City of Richmond
Urban Development Division

Report to Development Permit Panel

To: Development Permit Panel
From: Raul Allueva
Director of Development
Date: June 22, 2004
File: DP 04-268678
Re: **Application by 675106 B.C. Ltd. for a Development Permit at 10651 and 10671 Odlin Road**

SHADOW ANALYSIS

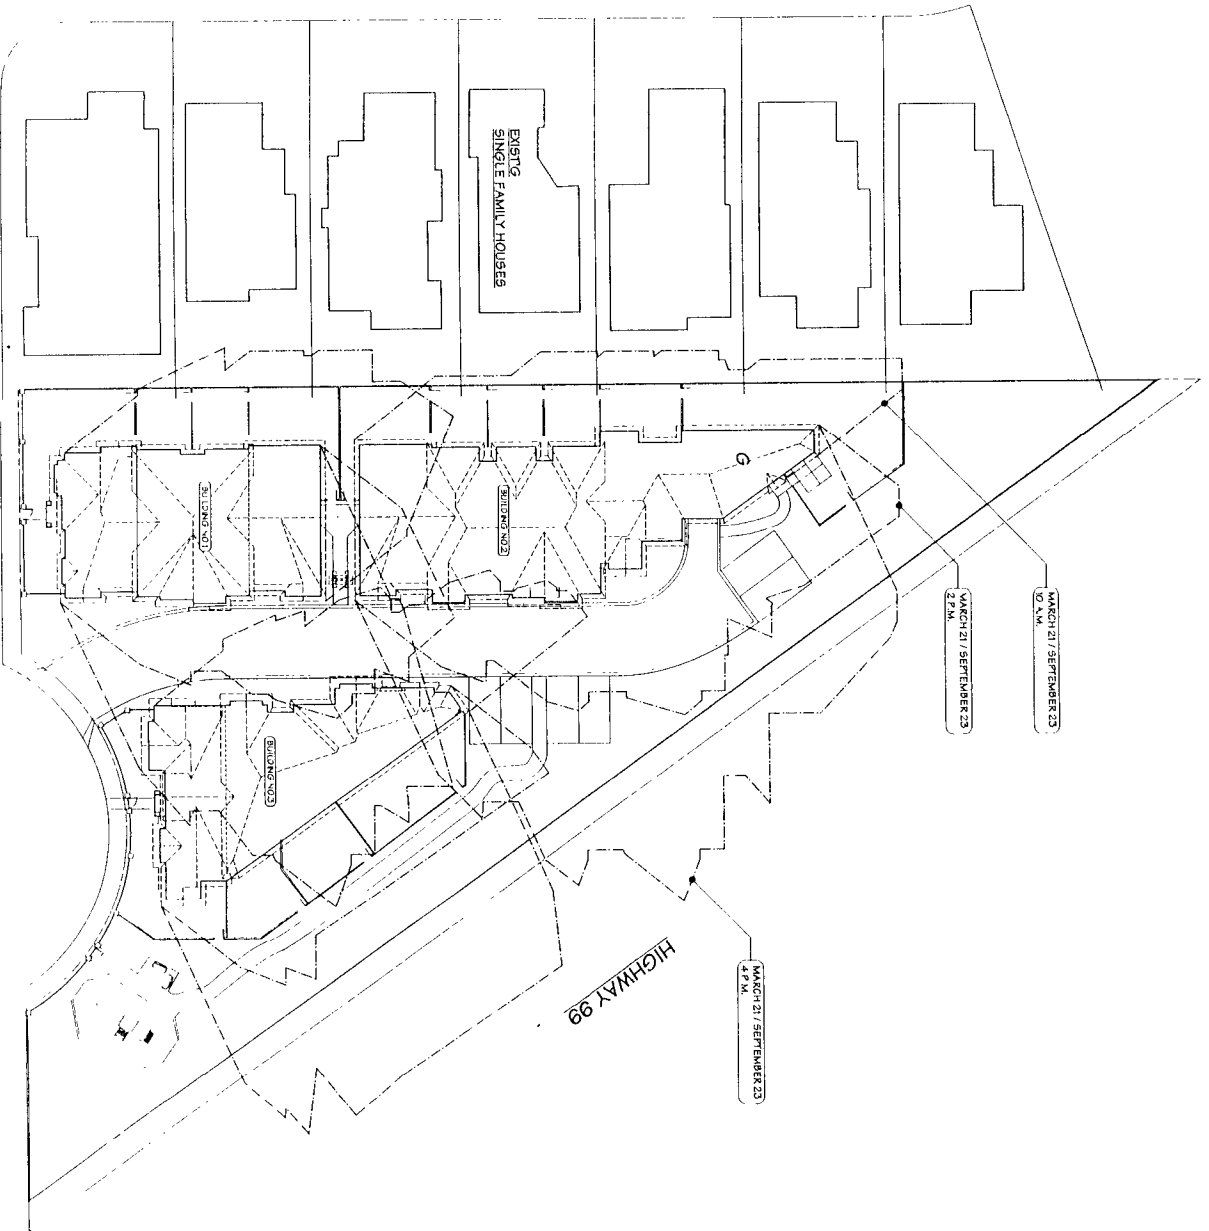
- A shadow analysis identifies that the development will have a minor impact on the availability of morning sun to a portion of the back yards of the adjacent single-family homes. However, availability of afternoon sun is not affected;
